Access Compliance Report

Public Rights-of-Way

(Curb Ramps)

Intersection ID: 28255	Main Street: REA_RD	Cross Street: ARDREY_KELL_RD	Location: NW
ADA ID: 9F54DBBC5D84	Ramp Type: Perp	Initial Pass/Fail: Fail	Overall Compliance: No
Severity Score: 21.25			
Codes/Mitigation Info/Possible Solution		Field Measurements/Component Compliance

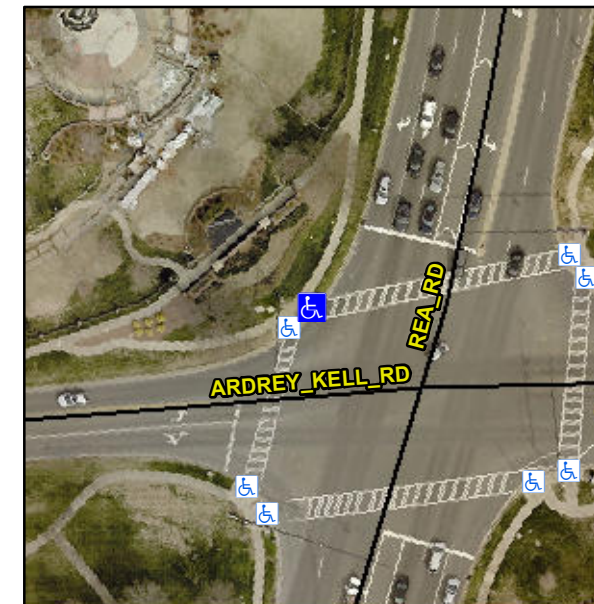
Not Found, R304.5.1, R304.2.2

Compliance	Description	Data	Compliance	Description	Data
N/A	Ramp Length (in)	74.0	No	Ramp Slope (%)	10.8
No	Ramp Width (in)	39.0	Yes	Ramp XSlope (%)	0.2
N/A	Flare Type LT	N/A	N/A	Flare Type RT	N/A
N/A	Flare Slope LT (%)	N/A	N/A	Flare Slope RT (%)	N/A
N/A	Flare Traversable LT?	N/A	N/A	Flare Traversable RT?	N/A
N/A	Landing Length (in)	N/A	N/A	DWS Provided?	N/A
N/A	Landing Width (in)	N/A	N/A	DWS Contrast?	N/A
N/A	Landing Slope (%)	N/A	N/A	DWS Length (in)	N/A
N/A	Landing X Slope (%)	N/A	N/A	DWS Full Width?	N/A
N/A	Landing Curb? (Y/N)	N/A	N/A	DWS Offset (in)	N/A
N/A	Shared Landing?	N/A			
N/A	Gutter Ponding?	N/A	N/A	Gutter Slope (%)	N/A
N/A	Gutter Lip Ht (in)	N/A	N/A	Gutter X Slope (%)	N/A
N/A	Painted X Walk1?	Yes	N/A	Painted X Walk2?	N/A
	X Walk 1 Direction	To E		X Walk 2 Direction	N/A
N/A	X Walk 1 Width (in)	102.0	N/A	X Walk 2 Width (in)	N/A
	X Walk 1 Slope (%)	0.1		X Walk 2 Slope (%)	N/A
	X Walk 1 X Slope (%)	0.6		X Walk 2 X Slope (%)	N/A

Remove & Replace Entire Ramp.
